**HARTZELL PROPELLER INC.**  
**SERVICE BULLETIN**  
**HC-SB-61-392**

**108298 Cylinder Bushing and 108346 Hub Bushing**

**108298 Cylinder Bushing  
Figure 1**

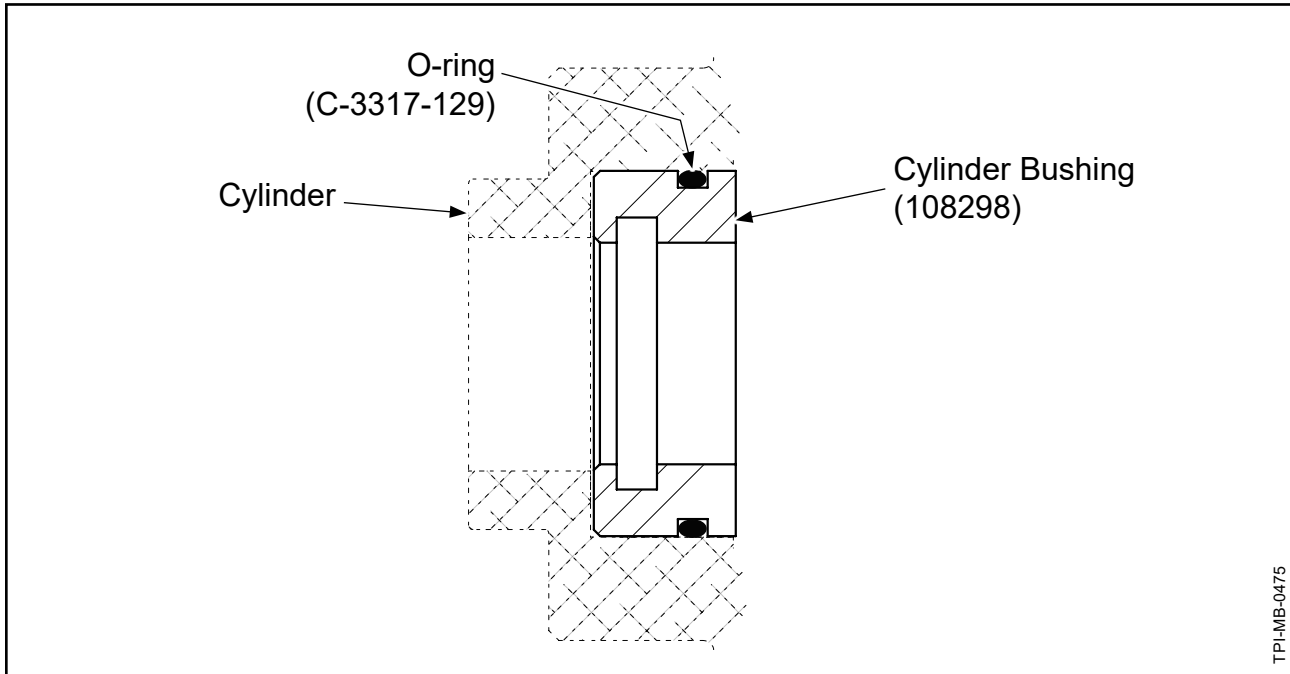
- (1) Hartzell Propeller Inc. has received reports of oil leaking at the A-3784 cylinder bushing on affected propellers.
  - (a) Hartzell is introducing the 108298 cylinder bushing as a replacement for the A-3784 cylinder bushing on affected propellers.
    - 1 The 108298 cylinder bushing has a machined O-ring groove on the OD of the bushing. This provides a more consistent seal between the bushing and the cylinder to prevent oil leaks. Refer to Figure 1.

- (a) Affected propellers manufactured by Hartzell after the release date of this Service Bulletin will incorporate the 108298 cylinder bushing.
  - (b) Existing inventory of A-3784 cylinder bushings must be discarded.

**108346 Hub Bushing  
Figure 2**

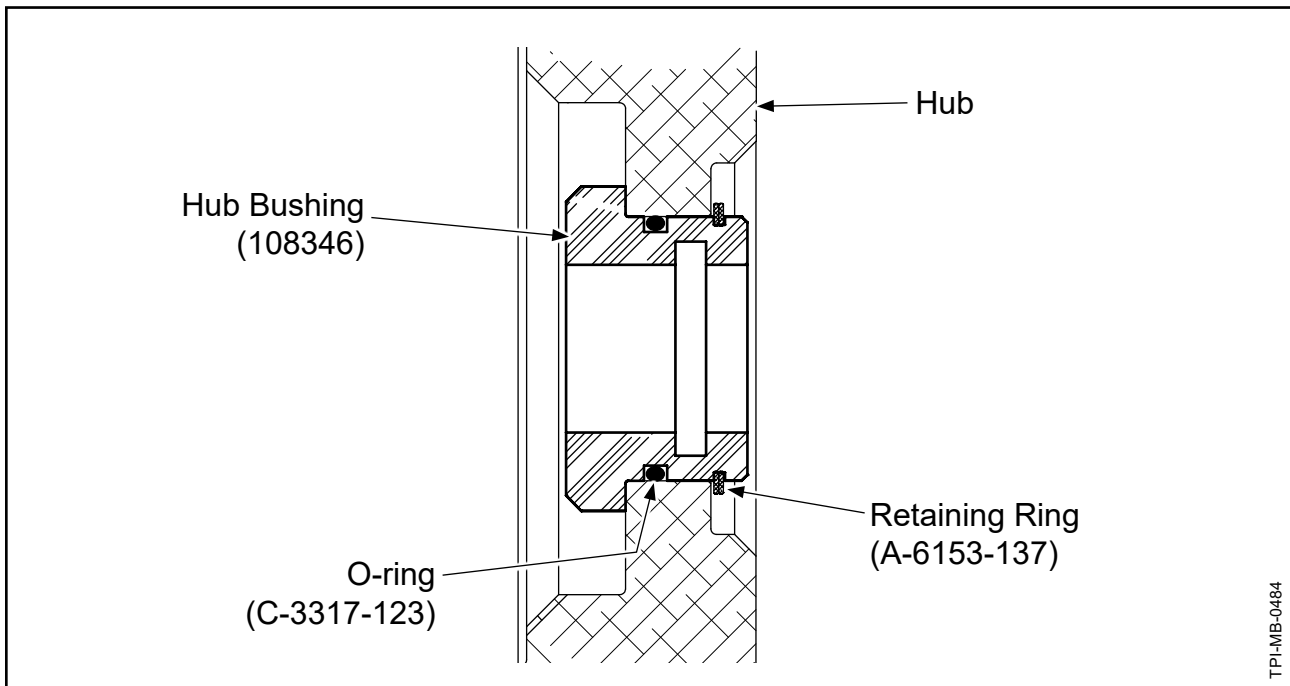
- (2) Hartzell Propeller Inc. has received reports of oil leaking at the 104903 hub bushing on affected propellers.
  - (a) Hartzell is introducing the 108346 hub bushing as a replacement for the 104903 hub bushing on affected propellers.
    - 1 The 108346 hub bushing has a larger O-ring groove on the OD of the bushing.
    - 2 The larger O-ring (p/n C-3317-123) used with the 108346 hub bushing provides a more consistent seal between the bushing and the hub to prevent oil leaks. Refer to Figure 2.

- (3) This Service Bulletin introduces the 108346 hub bushing and C-3317-123 O-ring as replacements for the 104903 hub bushing and C-3317-026-2 O-ring used on affected propellers.
